Form C-103

2. Name of Operator **Marathon Oil Permian, LLC.**

Well Procedure

Otis 33 #2

Wellbore Schematic
Well Name: OTIS 33 2

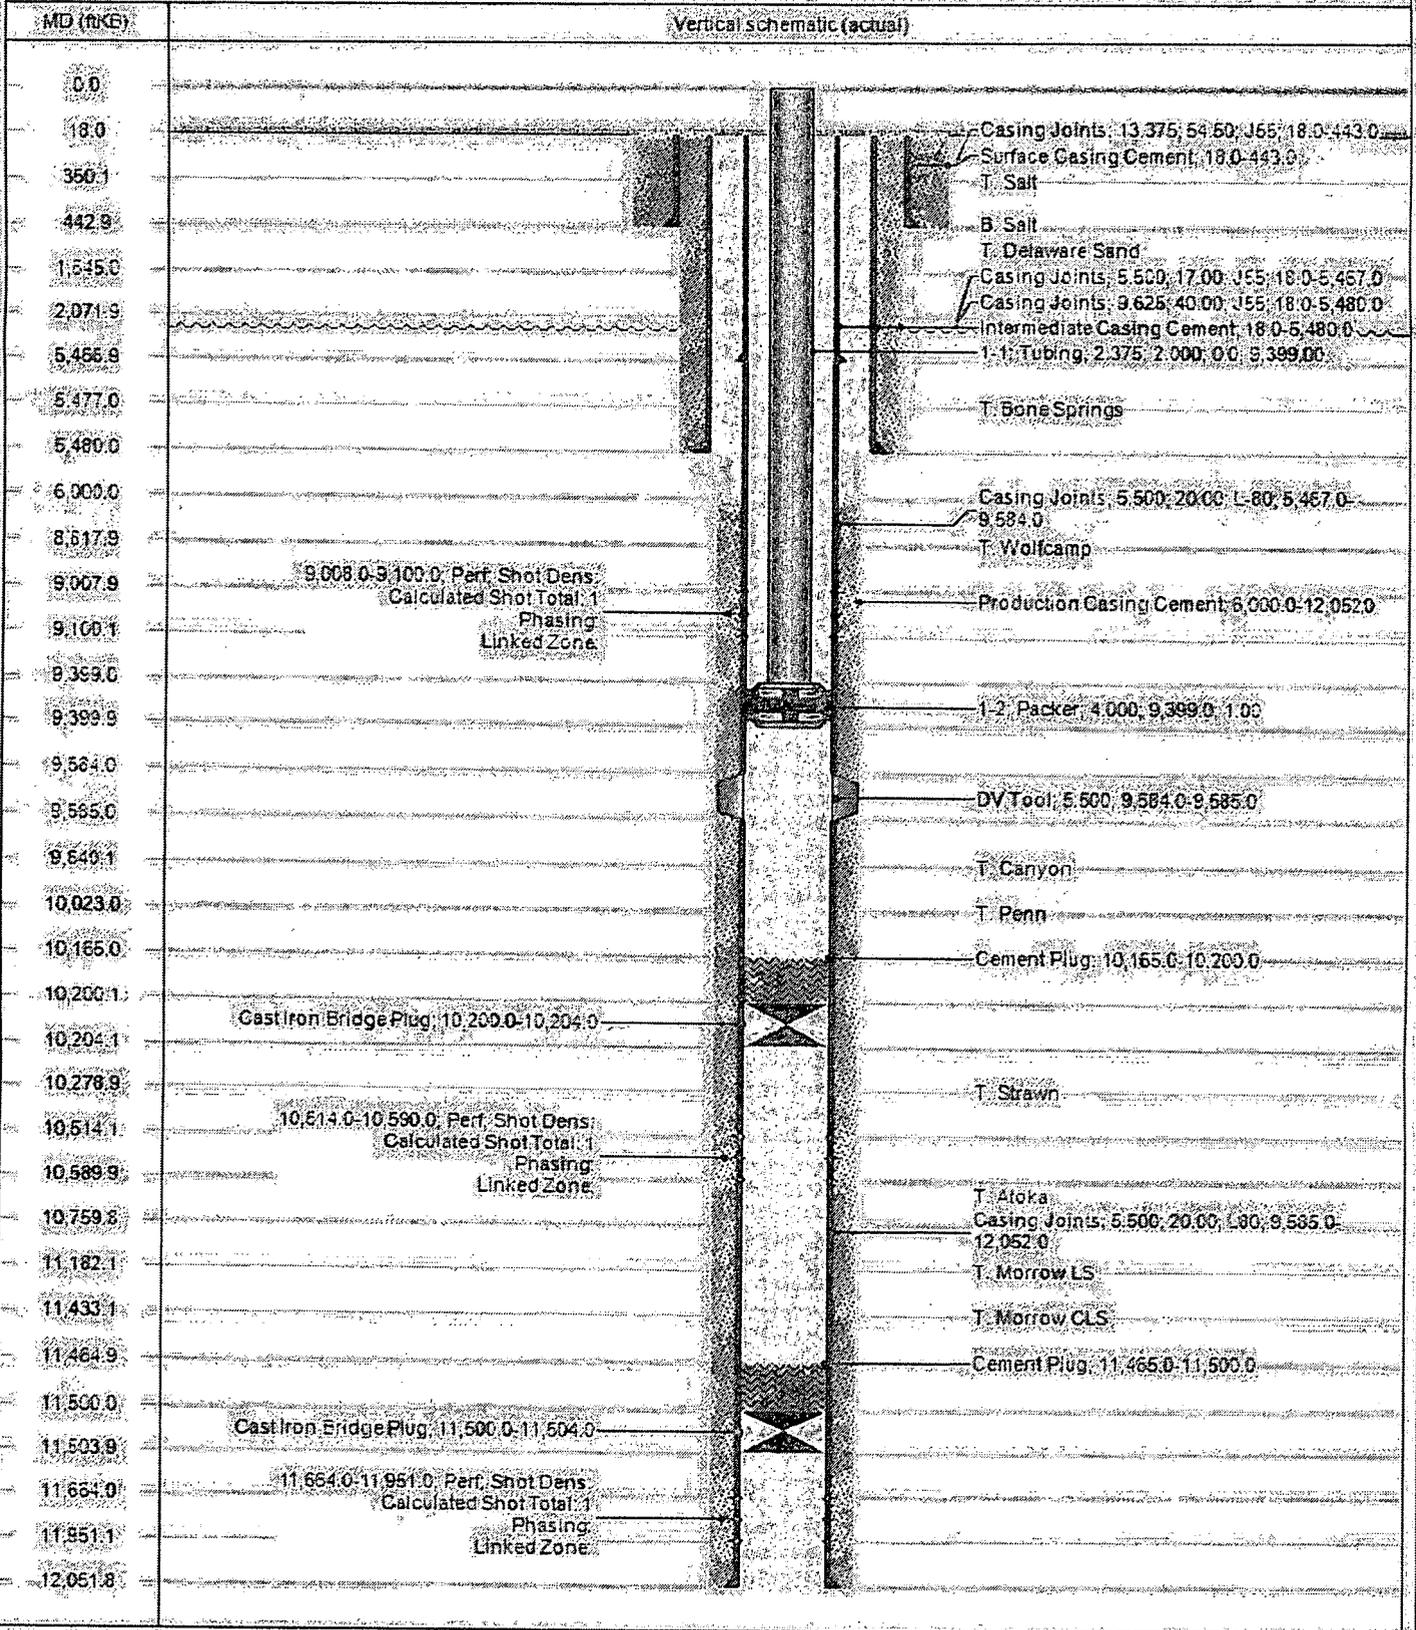
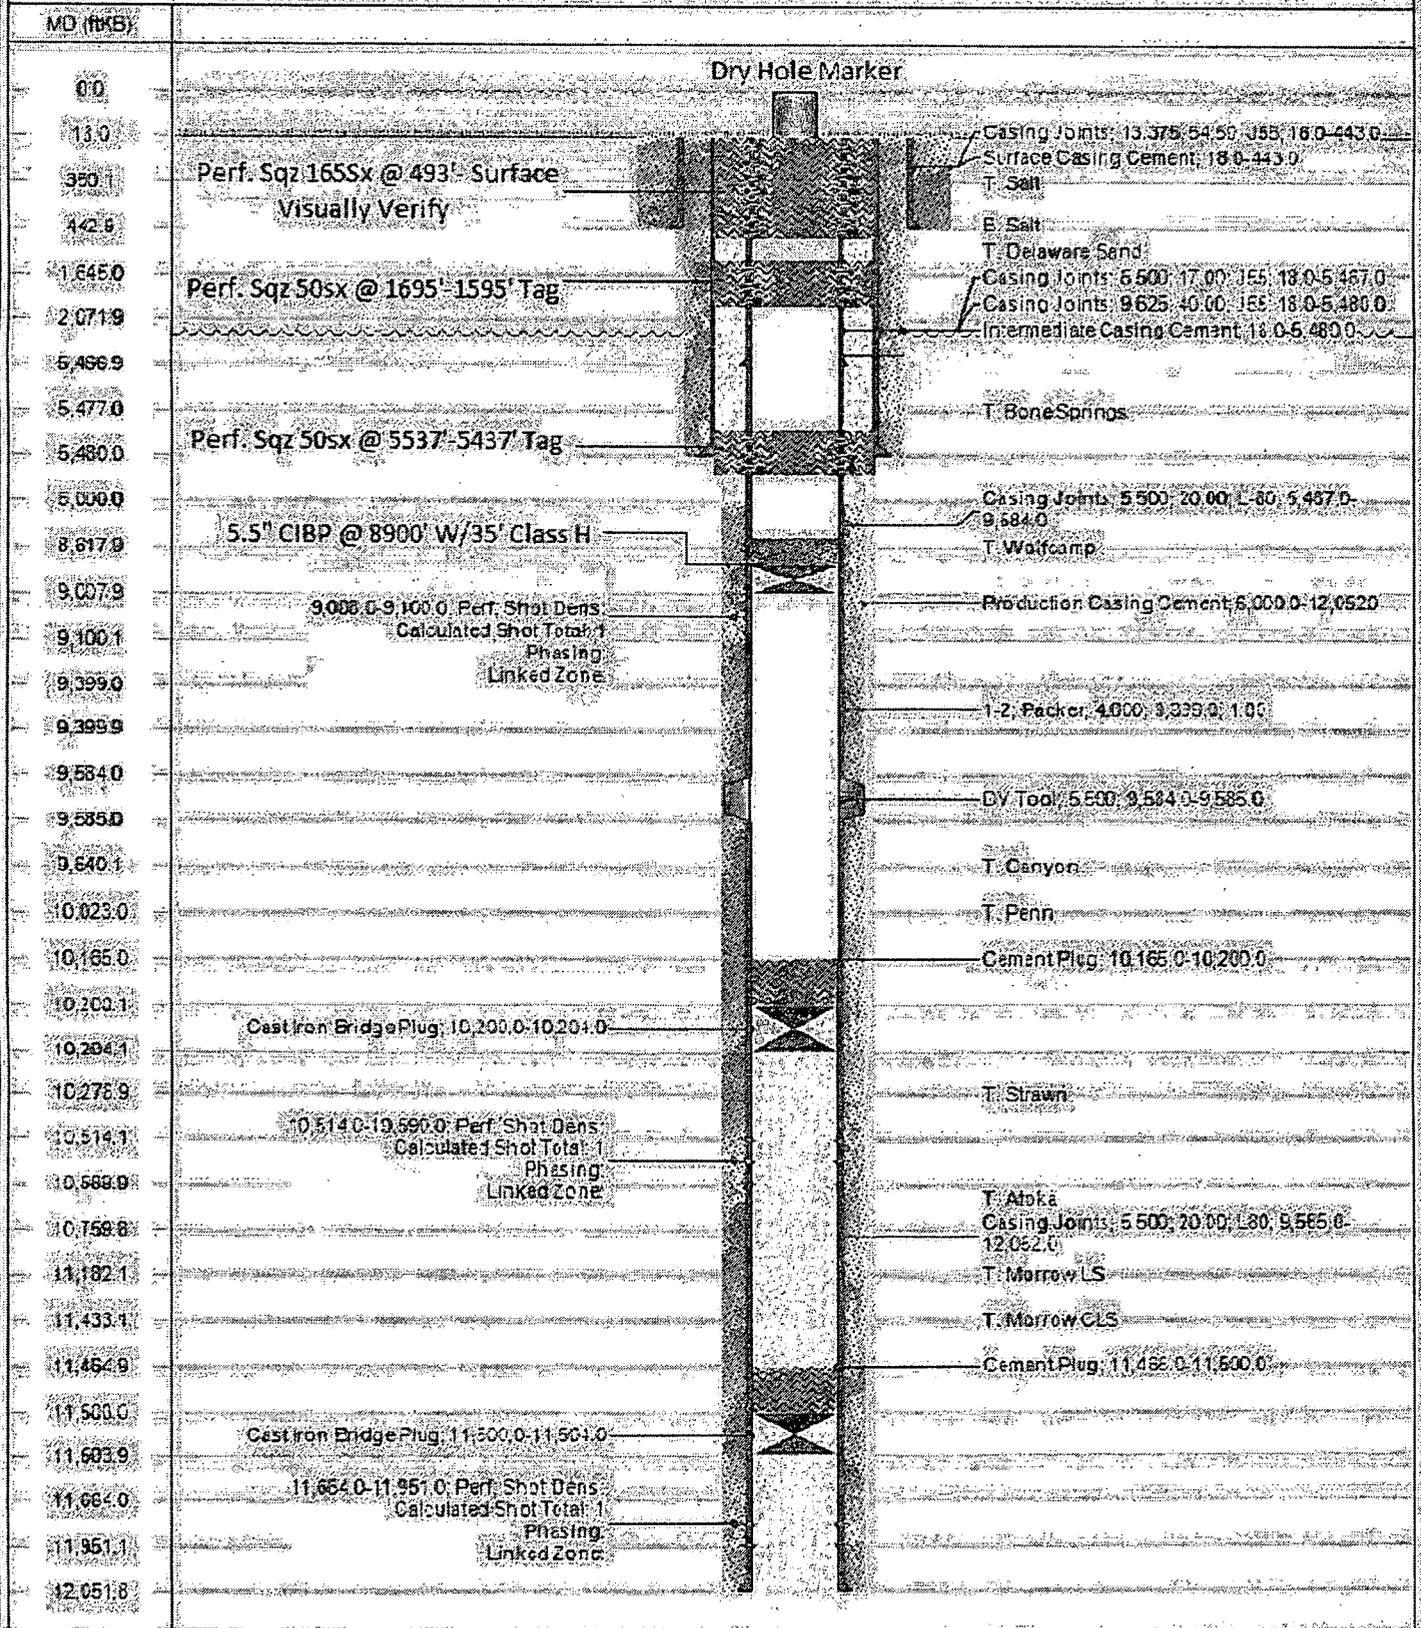
8908'
 1. CIBP @ **8,900'** w/35'
 2.50 sx @ **5537-5437'** P.S. Tag. **5530'**
 3.50 sx @ **1695-1595'** P.S. Tag.
 4.165 sx @ **493'-surf.** P.S. & verify. Install DHM.

Spud Date: Rig Release Date: **MUST BE PLUGGED BY - 3/4/2021**

P&A mud between all plugs. Closed loop fluids to
